## SERVICE BULLETIN

**APPLICABILITY:** 2020-21MY Legacy & Outback  
2019-21MY Forester  
2021MY Crosstrek

**NUMBER:** 09-80-21R

**SUBJECT:** DTC # P2682 & P26Ax\*\* / Thermo Control Valve – Design Change

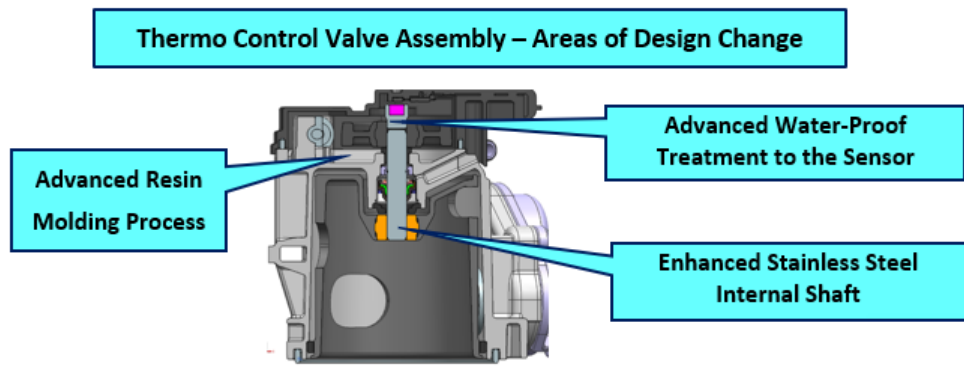
This bulletin announces availability of a new thermo control valve assembly. The new valve contains an enhanced stainless steel internal shaft for optimized durability along with advanced water proofing for the sensor portion. A new resin molding process was also used in production. These changes were implemented prevent sensor corrosion which can cause DTCs P2682 and/or P26A\*\*.

**NOTE:** The new valve assembly comes with a replacement o-ring.

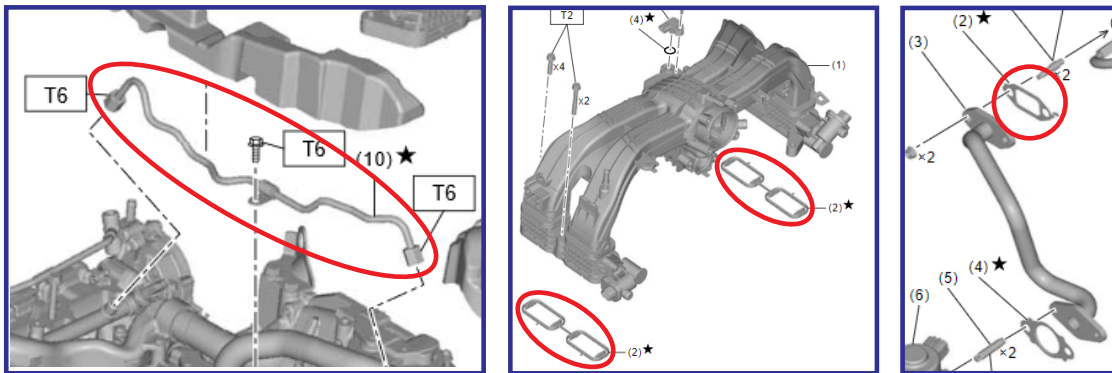
- The Service Manual uses a black star (★) in the component breakdown illustrations to indicate one-time use parts. The high-pressure fuel delivery pipe, intake manifold gaskets, and EGR cooler gaskets are one-time use parts (shown below).
